COMMONWEALTH OF KENTUCKY
BEFORE THE PUBLIC SERVICE COMMISSION

APPLICATION OF LOUISVILLE GAS AND)	
ELECTRIC COMPANY FOR AN ADJUSTMENT)	CASE NO.
OF ITS ELECTRIC AND GAS RATES AND FOR)	2016-00371
CERTIFICATES OF PUBLIC CONVENIENCE)	
AND NECESSITY)

RESPONSE OF
LOUISVILLE GAS AND ELECTRIC COMPANY
TO
KENTUCKY CABLE TELECOMMUNICATIONS ASSOCIATION'S
FIRST REQUESTS FOR INFORMATION
DATED JANUARY 11, 2017

FILED: JANUARY 25, 2017

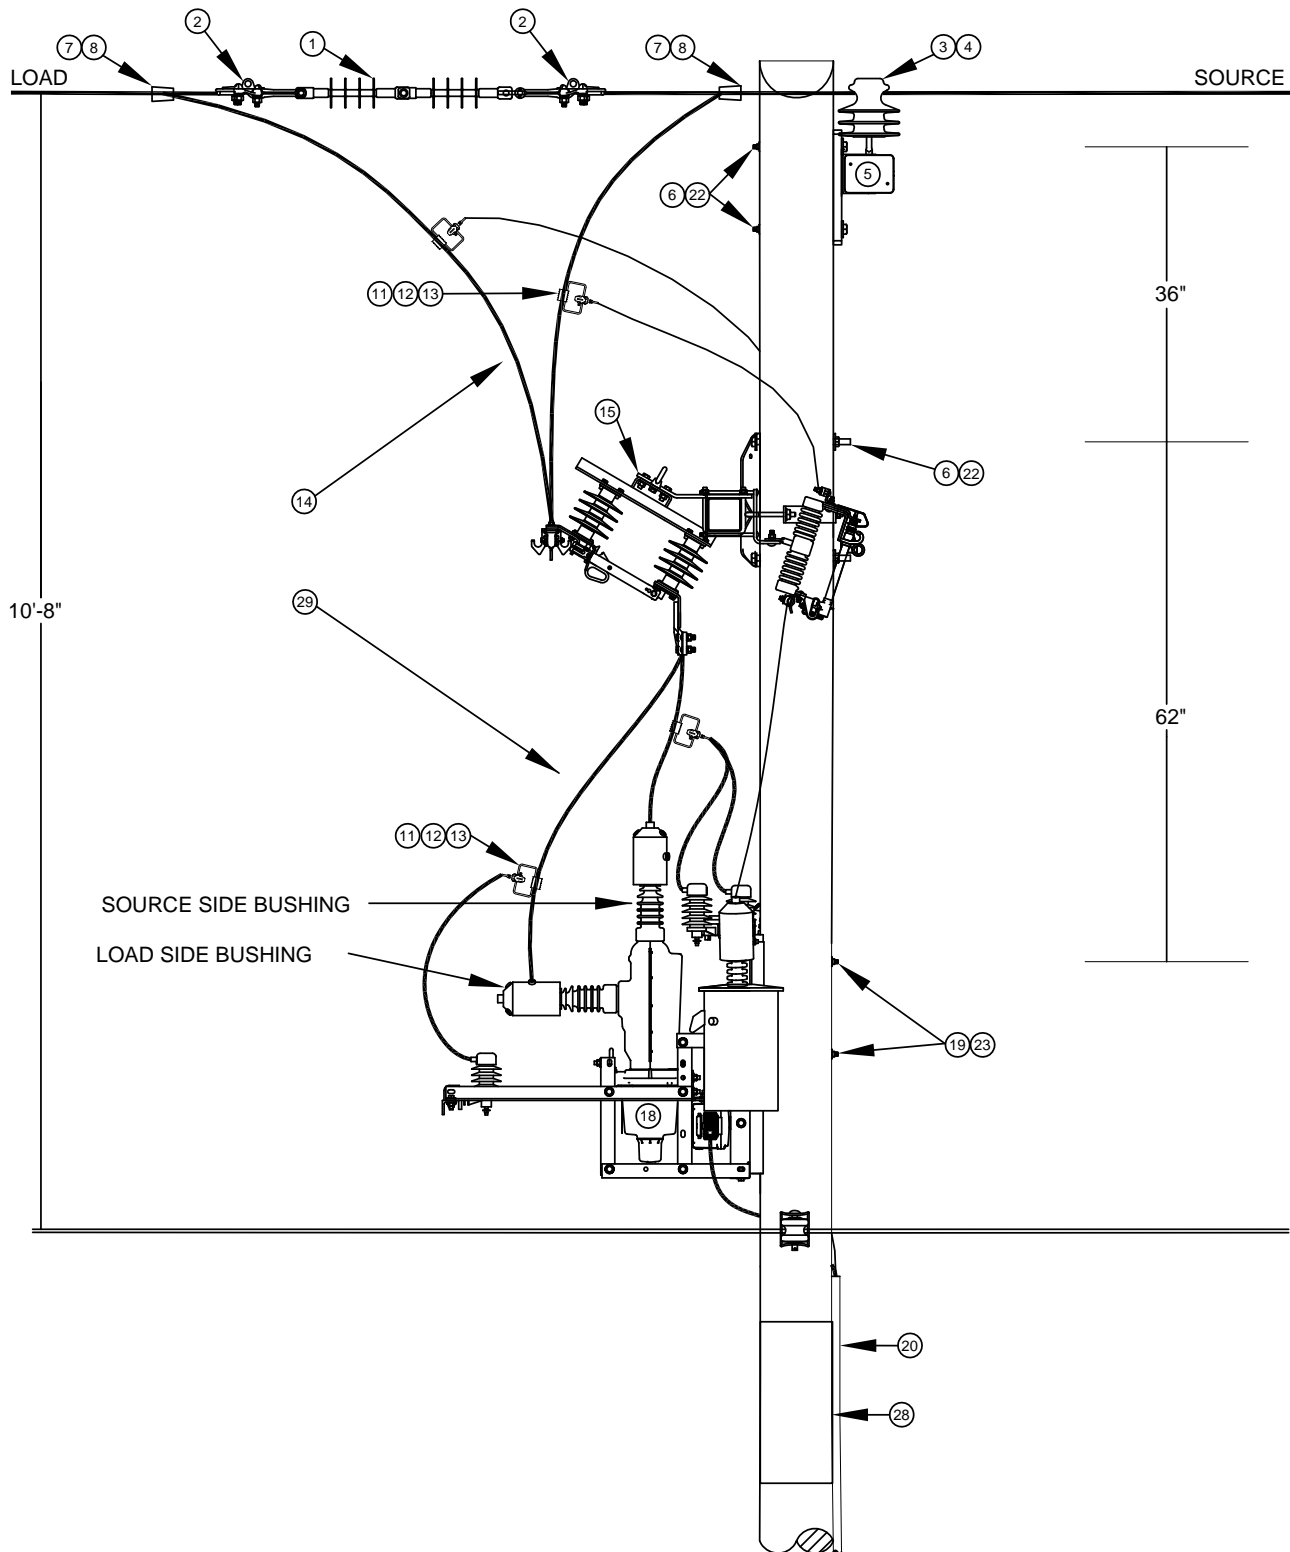
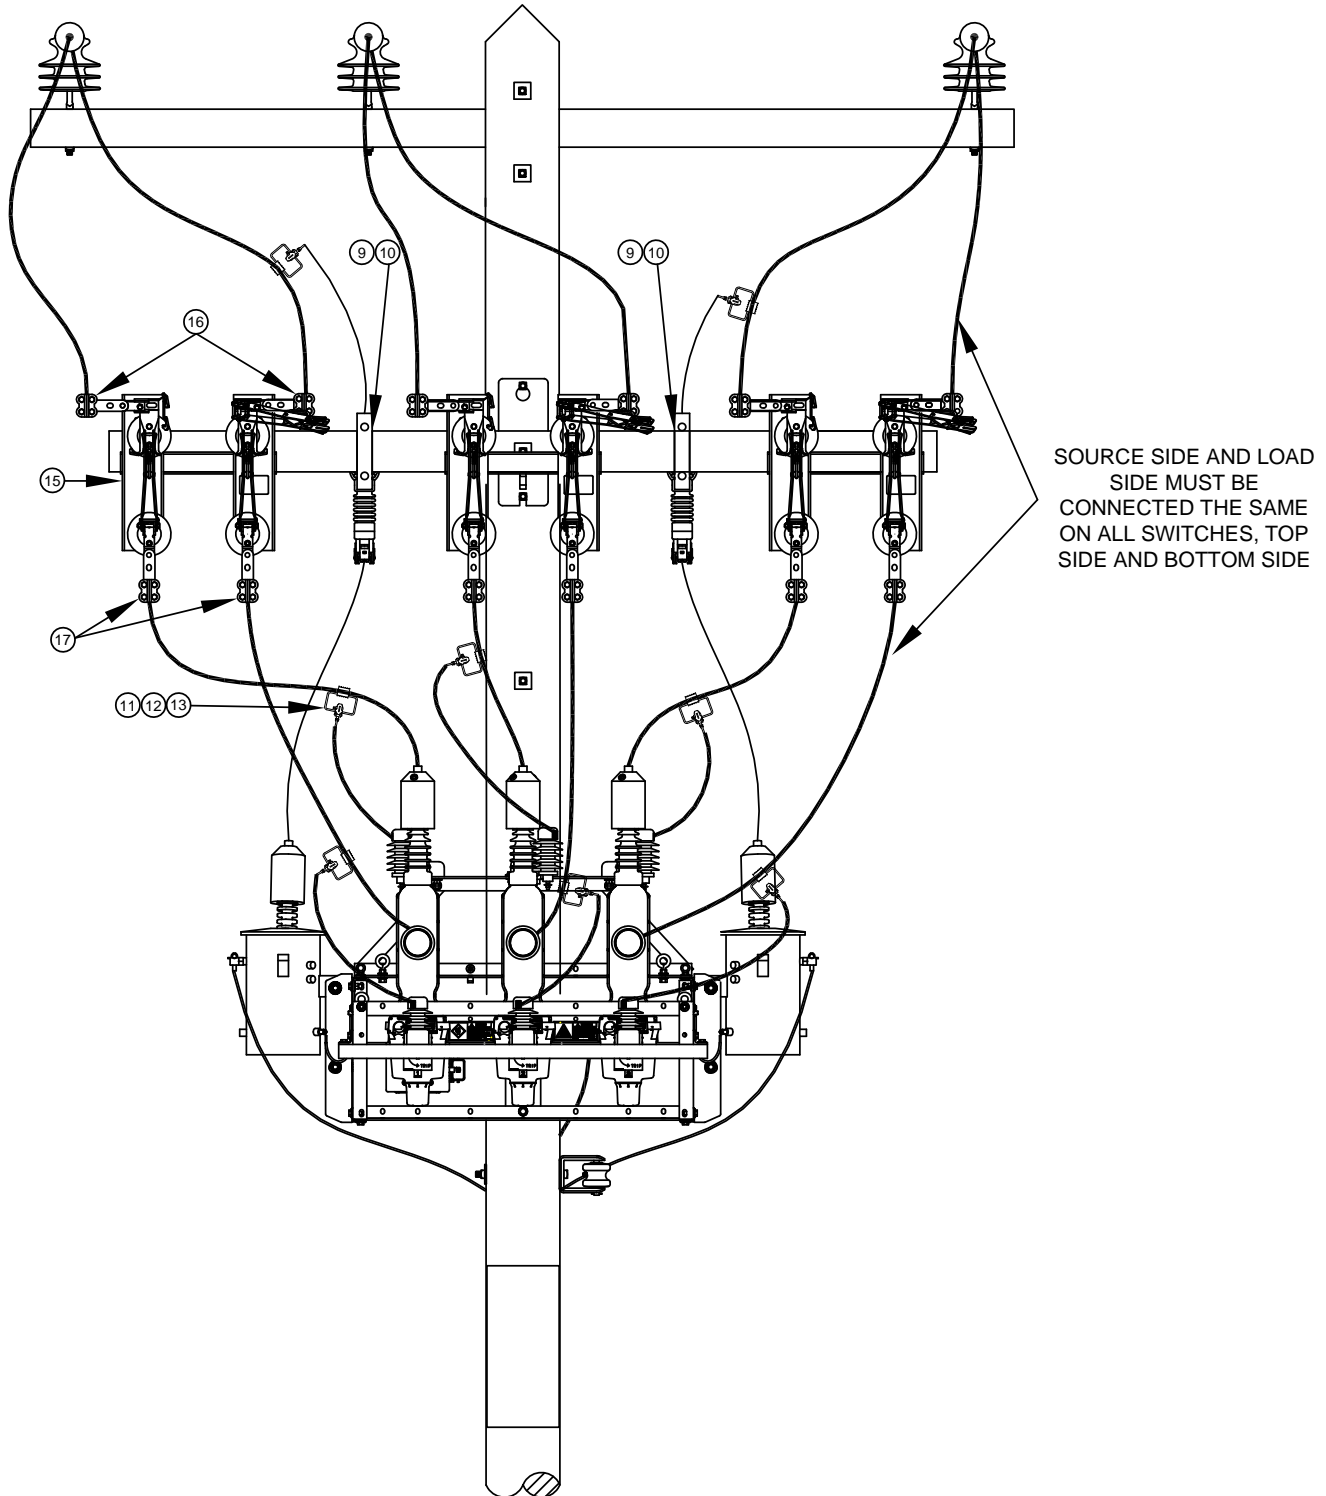
- Q-1-24. Please explain how the AMS and DA systems will make use of distribution poles, including the extent and nature of and attachment of wires and facilities to Poles, the Pole space to be used, and the location on the Poles to be used by any such wires and facilities.
- a. Provide data related to any proposed installation of meters and/or equipment necessary to support the meters on Your Poles. Please include data showing where the equipment will be located and changes to existing pole facilities and Attachments that may be required to accommodate proposed AMS and DA systems as well as the basis for any such changes.

A-1-24. The AMS system will require the installation of radio-frequency (RF) communications infrastructure on distribution poles. This infrastructure facilitates the transmission of the meter data from the advanced meters to Company back-office systems.
